REV	DESCRIPTION	DATE	BY	ECN	THOR MOTOR COACH		
-		-	-	11147	DRAWN BY	SHEET	DATE
1	ADDED 10 AMP FUSE AT F10 FOR HVAC AT 1F	12/29/14	DRC	11001	1	1	11/13/14
2	CHANGE REAR VISION FUSE, F7, FROM 5 AMP TO 3 AMP	9/27/17	MSH	14666	BUSSMANN CHASSIS DISB. BOX		
					MODEL		
					SEE PRINT USAGE		
					© CONFIDENTIAL AND PROPRIETARY INFORMATION. ANY REPRODUCTION IN PART OR AS A WHOLE WITHOUT OUR EXPRESSED WRITTEN CONSENT IS PROHIBITED.		
					DRAWING NUMBER		
					TEE1133-02

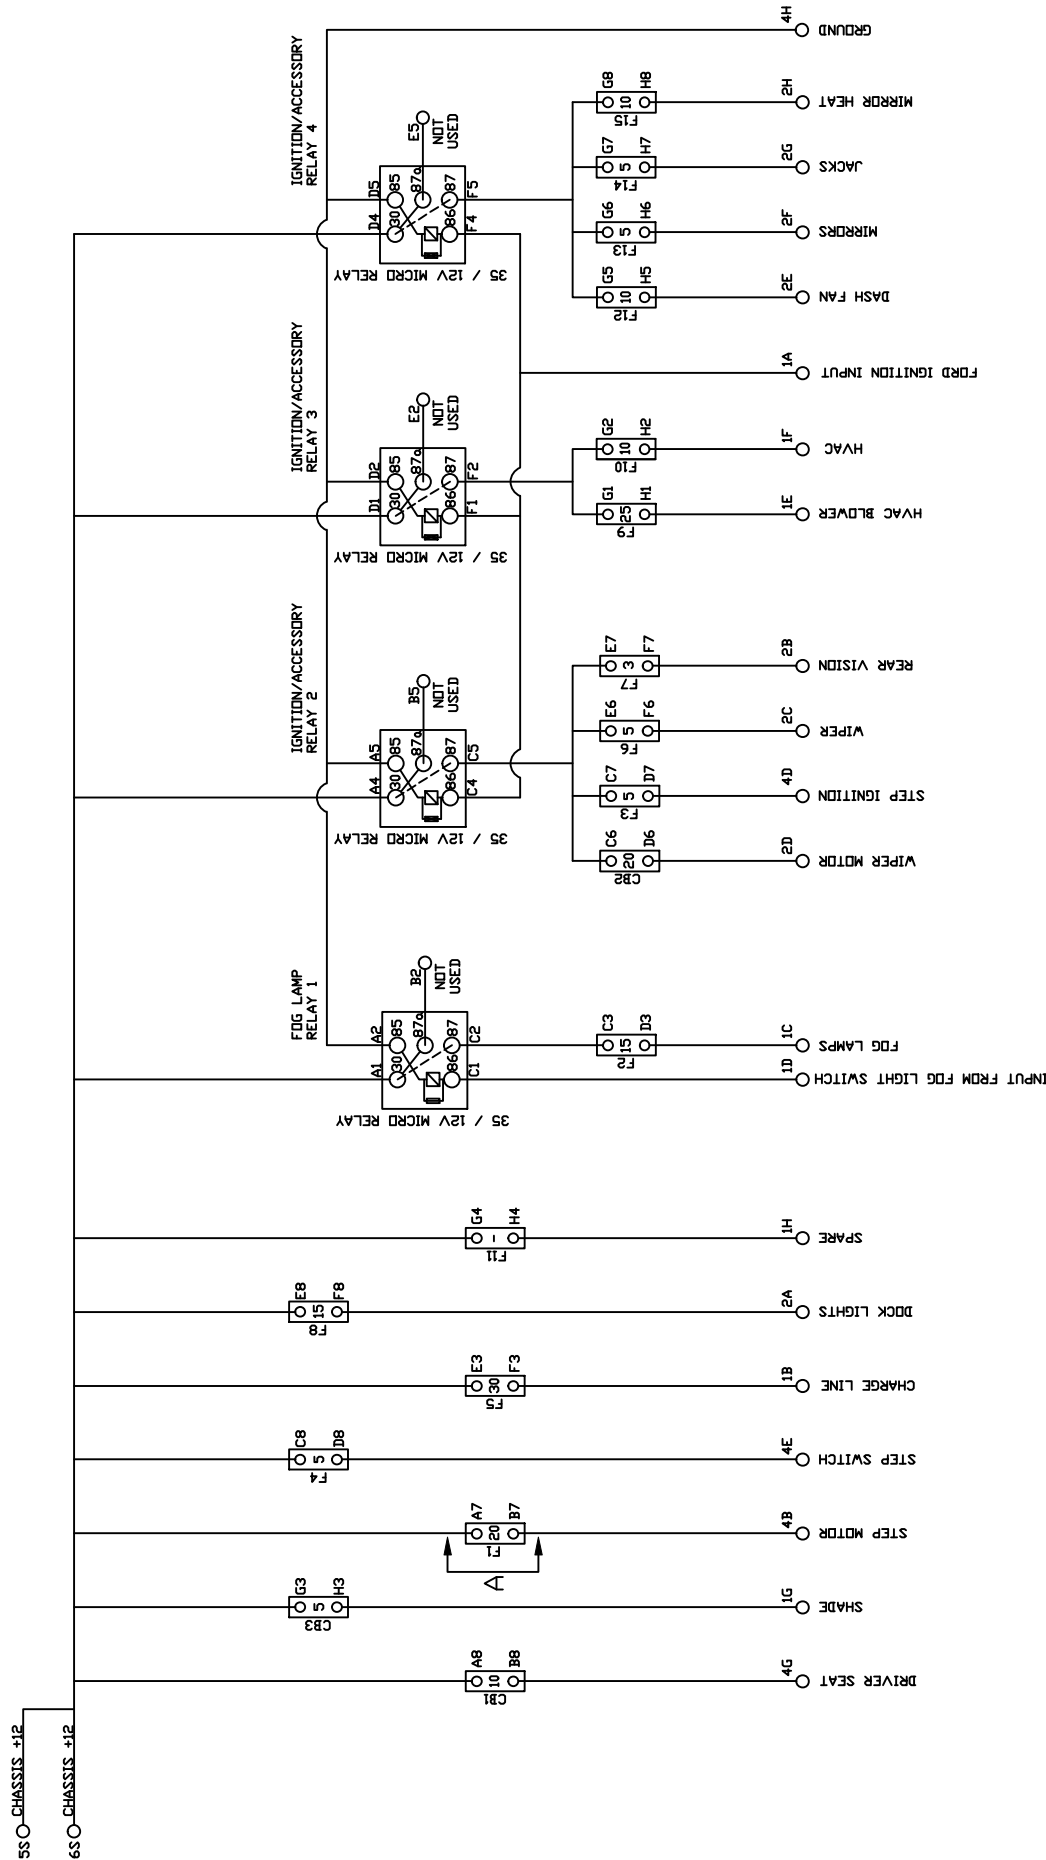
ON OUTLAW 37LS, AND 37MD
USE 20 AMP CIRCUIT BREAKER
